CANTON TOWN HALL

ADVERTISEMENT FOR BID
Town Hall Renovation Bid

Canton Town Hall Reno
Project No.: 2023-001-02
Issue to: Bidders

Town of Canton, Owner
Contract Document Date: July 07, 2025
Addendum Date: April 13, 2026

A1 DEMO SOUTH ELEVATION
1/8" = 1'-0"

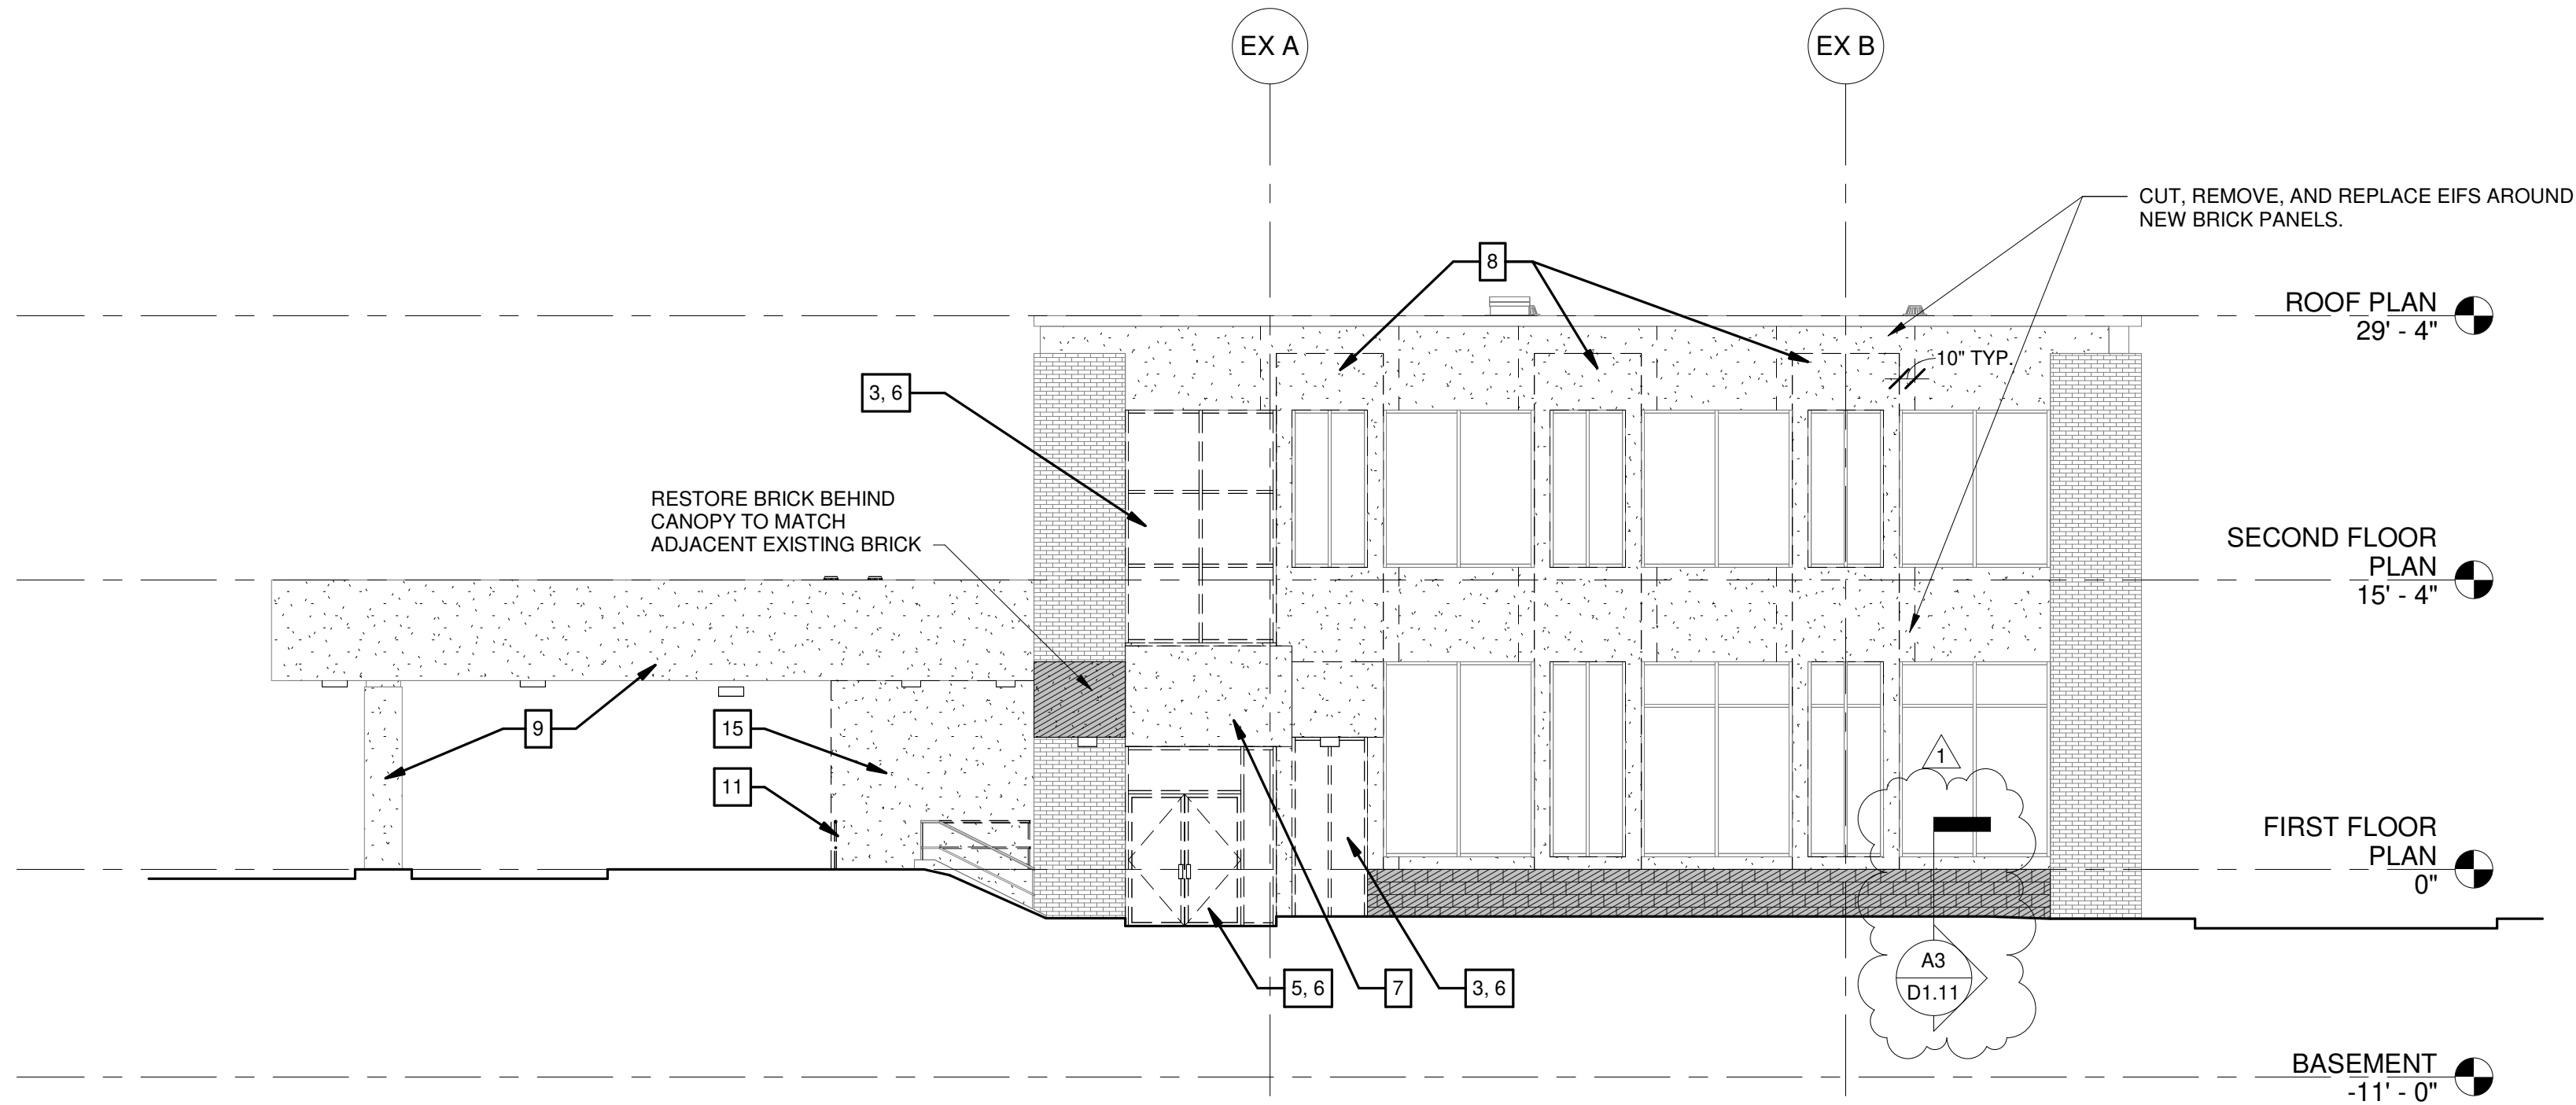
- 1) The contractor should provide this on behalf of the owner.
- f) Will you please clarify if the existing South Elevation Planting Bed is to be fully demoed and rebuilt (per A1/D2.01) or if it is to be re-faced without demo (per A1/A2.01)? If it is to be demoed and rebuilt, please provide details / specs.

- 1) The top layer of brick & CMU will need to be removed and rebuilt. A new stucco finish is called for once the substrate is repaired.
- g) (2) "Type-Q" In-ground lighting fixtures are spec'd for flagpole lighting. However, no flagpole is shown in the drawings or specs. Please clarify.
